STAFF'S
REQUEST ANALYSIS
AND
RECOMMENDATION

03PR0268

Wendy's International, Inc.
(Wendy's - Route 10/Kingston Avenue)

REQUEST: Site Plan Approval.

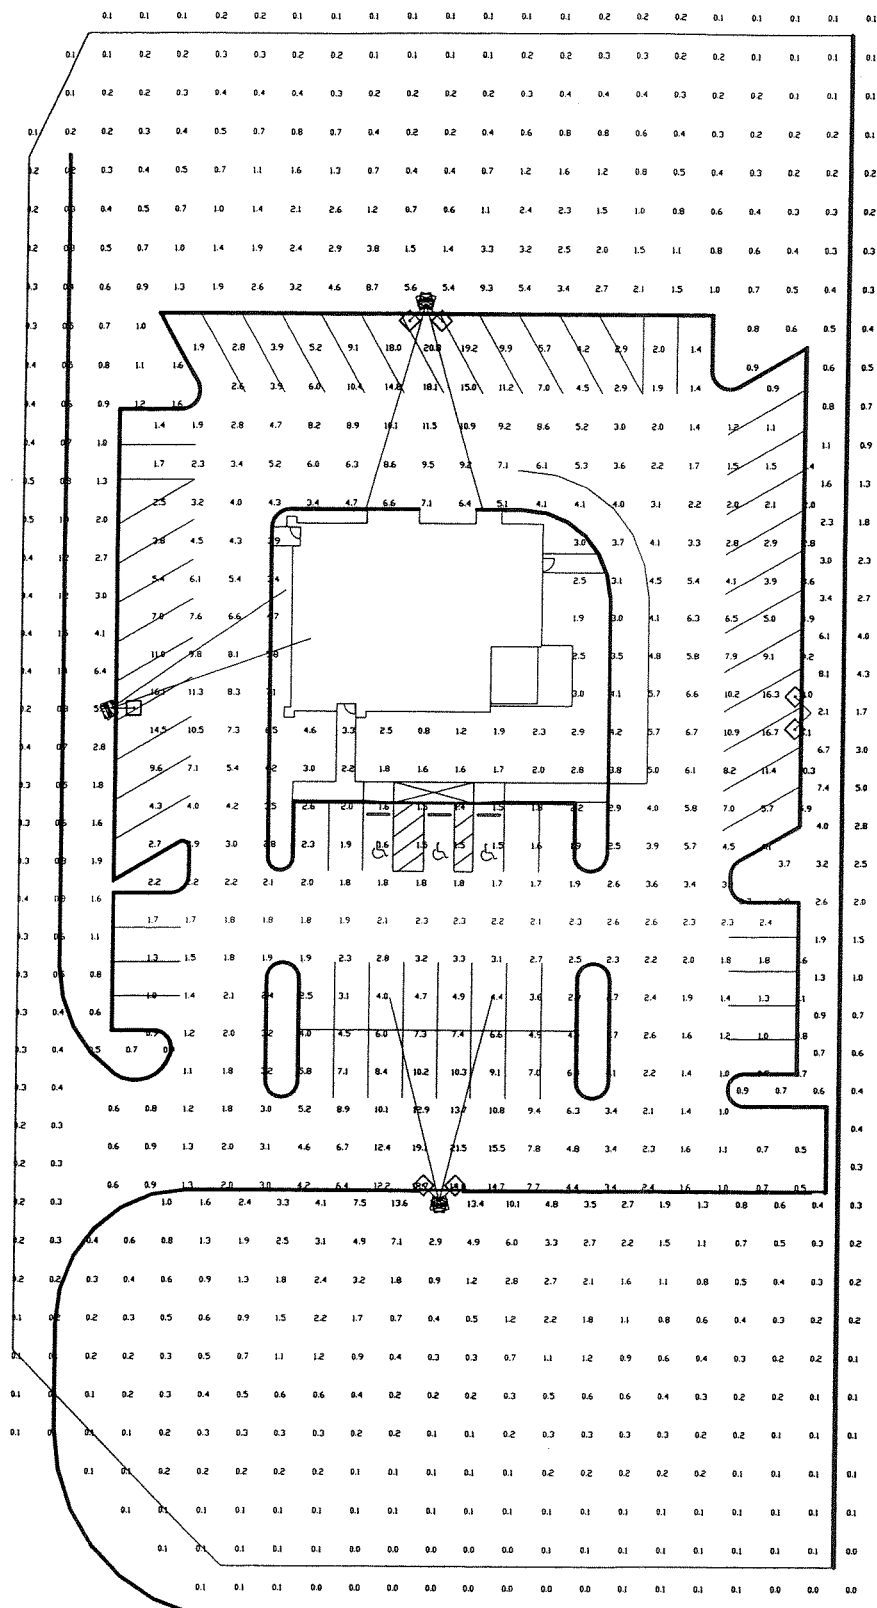
18. Revise the lighting plan as follows:
 - a.) Adjust location of proposed light pole located at the south end of the site to avoid the concrete curb inlet and storm pipe.

- b.) Delete pole mounted floodlights. Lighting fixtures must be shoebox cut-off type. Building illumination may be accomplished with ground-mounted fixtures equipped with glare shields.

- c.) Wall mounted H.I.D. fixtures must also have ninety (90) degree cut off configuration or have shields to conceal the light source and/or reflectors and to reduce glare off-site. (P)

Back Elevation
Chesterfield County, Virginia

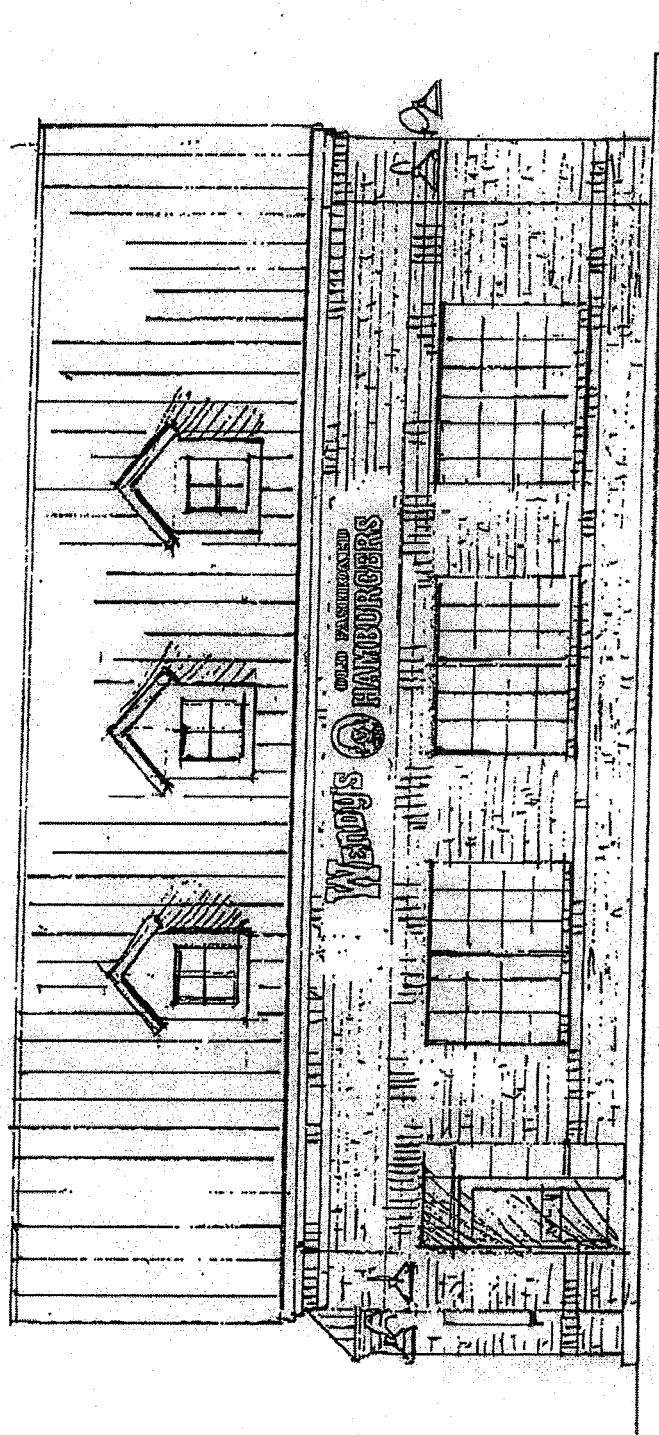
16. The architecture of the building shall conform with the elevations submitted and received April 29, 2003, and shall be compatible with the East Coast Gas Station building as follows:

- a.) The standing seam metal roof shall match the color of the standing seam metal roof on the existing adjacent East Coast Gas Station.
 - b.) The colonial style cornice shall be similar.

- c.) Brick color and grout shall be compatible.
 - d.) Windows shall have white frames and muntins. (P)
17. Subsequent to Planning Commission review, and prior to the release of the building permit, two (2) copies of the revised building elevations must be submitted to the Planning Department for approval in accordance with the Review Comments and Conditions of the Planning Commission approval. These elevations must be received separate of the construction document rolls which are submitted to the building inspections department.
